CITY OF ALBUQUERQUE

RE: CRESTVIEW SUBDIVISION (A-11/D1E1)
Engineers Certification for Release of Financial Guaranty
Engineers Stamp dated 11/12/2003
Engineers Certification dated 02/10/2005

CITY OF ALBUQUERQUE PUBLIC WORKS DEPARTMENT ENGINEERING DEVELOPMENT GROUP	
TITLE: CRESTVIEW SUBDIVISION	
ULTIMATE GRADING AND DRAINAGE PLAN	
Design Review Committee	City Engineer Approval
Mo./Day/Yr	Mo./Day/Yr
For Information Only	
City Project No. 726781	Zone Map No. A-11,12
Sheet 7	of 22

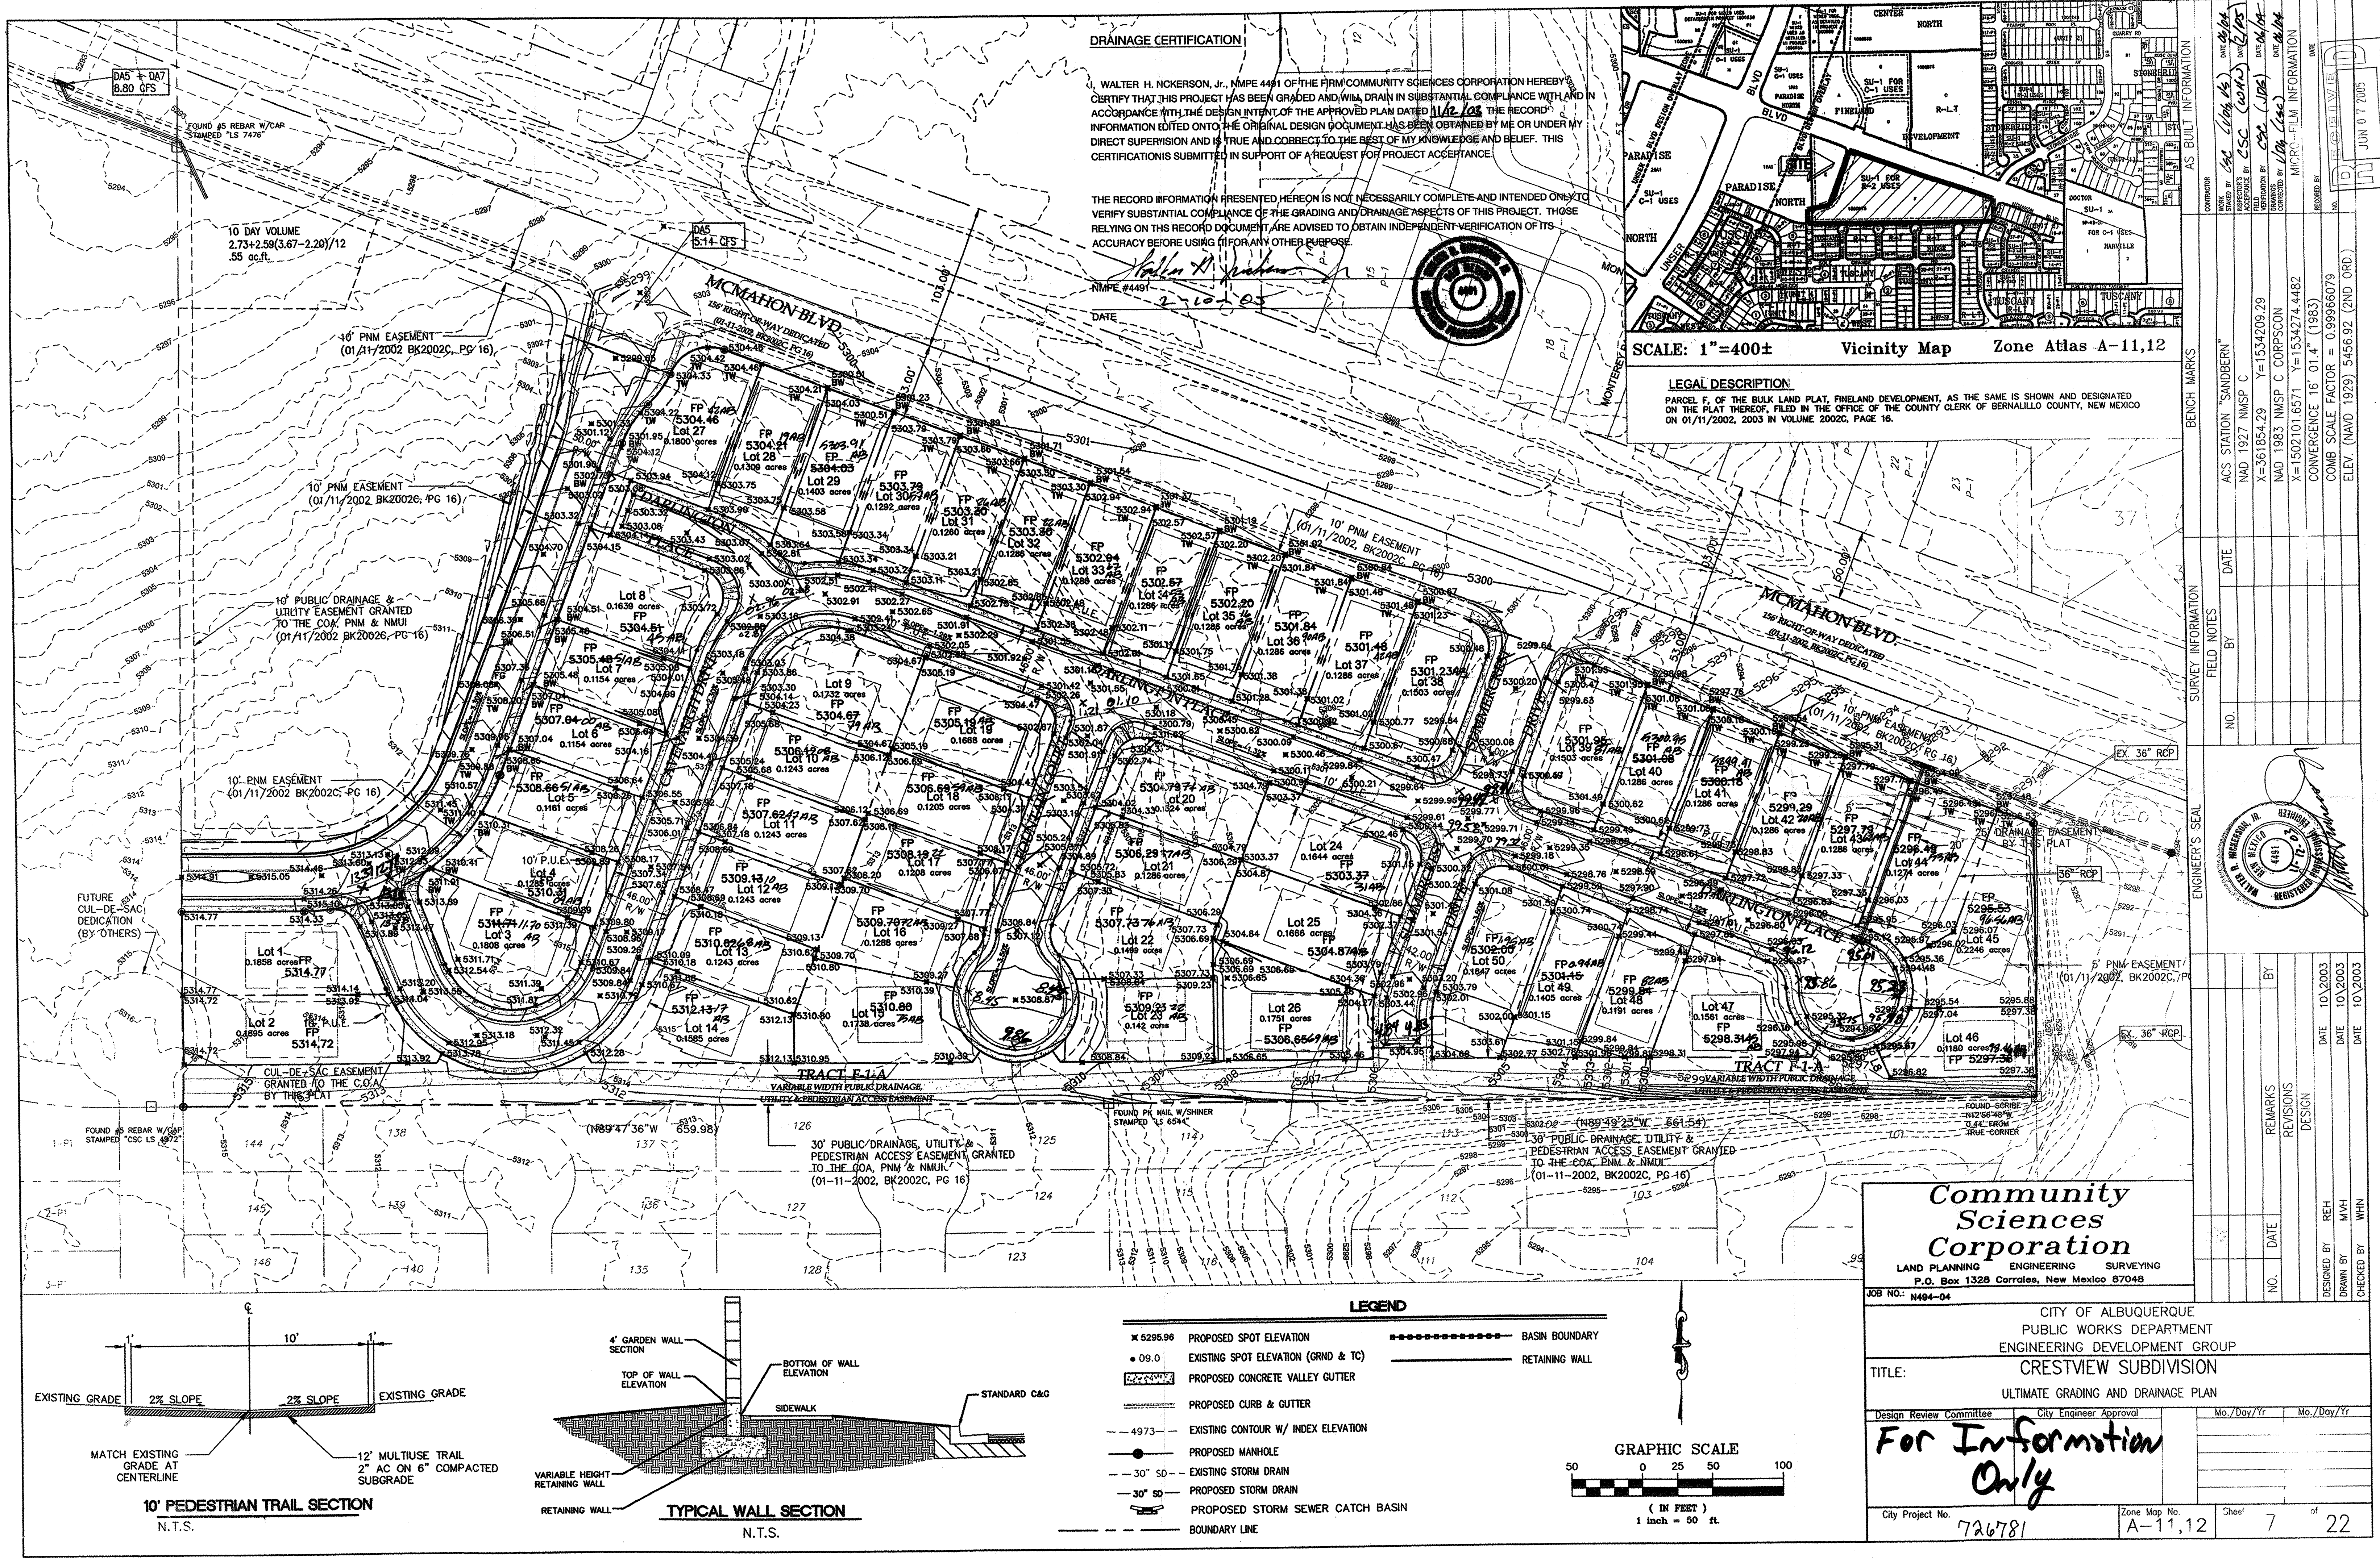
Based upon the information provided in your Engineer's Certification Submittal dated 06/07/2005, the above referenced plan is adequate to satisfy the Grading and Drainage Certification for Release of Financial Guaranty.
